ATR on Quality Control Check Report. (Apartments)

Flat No	B 505	QC report stage	Stage -3	Sl. No.	38007
Company	MPL	Project	MCP	Phase	-
Prepared by	Sravani K	Sign	<i>[Signature]</i>	Date	2017/21
Project Manager	Subbarreddy S.R	Sign	<i>[Signature]</i>	Date	2017/21
Receipt by QC date	19/7/21	Sign		Other	-
Receipt at HO date		Sign		Other	-
Checked By MD on		MD Sign		For filling	☐ Yes ☐ No
Recommendation that was made by QC: ☐ Stop further work. Submit ATR on QC report to QC team. Proceed only after recheck by QC. ☒ Stop further work. Proceed with work after submitting ATR on QC report to QC team.

Quality Control Check Report. Stage: After Finishing Stage III (Apartments)

MAYFLOWER PLATINUM

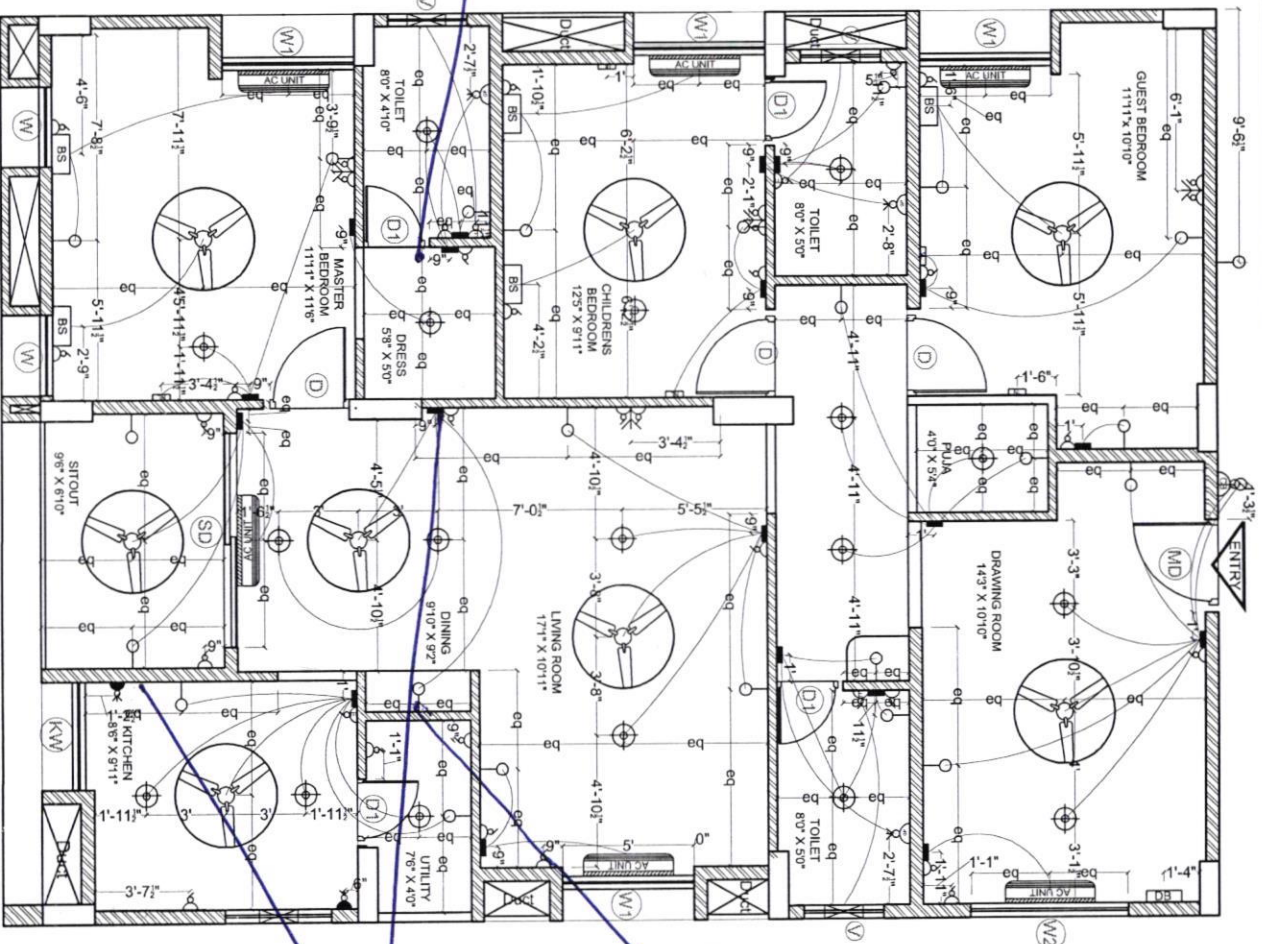
Other Changes: ① ~~3~~ ³ track / window all windows
② ~~4~~ ³ track under for floor under
③ wall to be removed beside common toilet (marked on plan) ~~to make~~

④ Pogg room wall tiles are to be provide by contractor

⑤ MBR w.c provide should be change south facing.

ELECTRICAL PLAN OF FLAT-B5

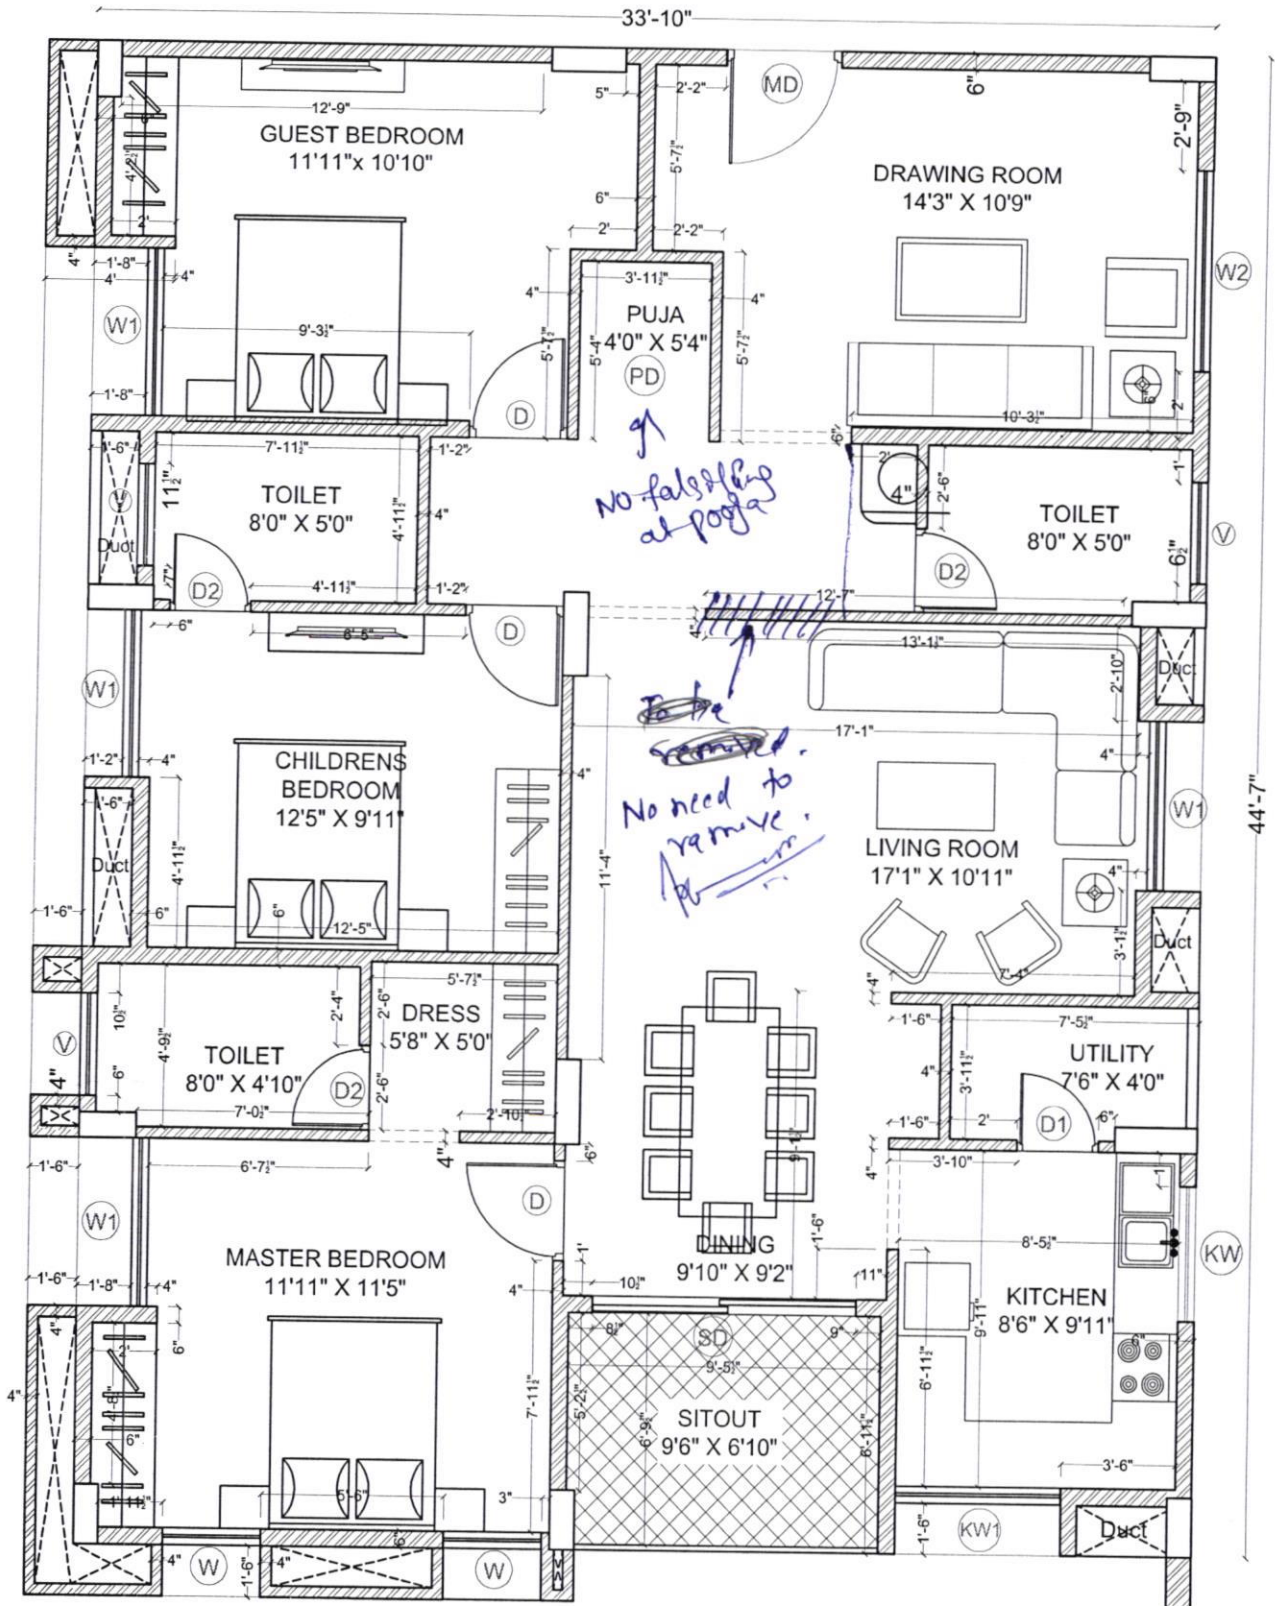
Changes in electrical points: (mark on plan)

- ① Increase ht of its above kitchen platform 6-model switch board.
- ② Dining Area wash basin ① 5amp socket & light pt secured. ~~1/10~~
- ③ 15 amp socket in Kitchen & dy marked on plan.
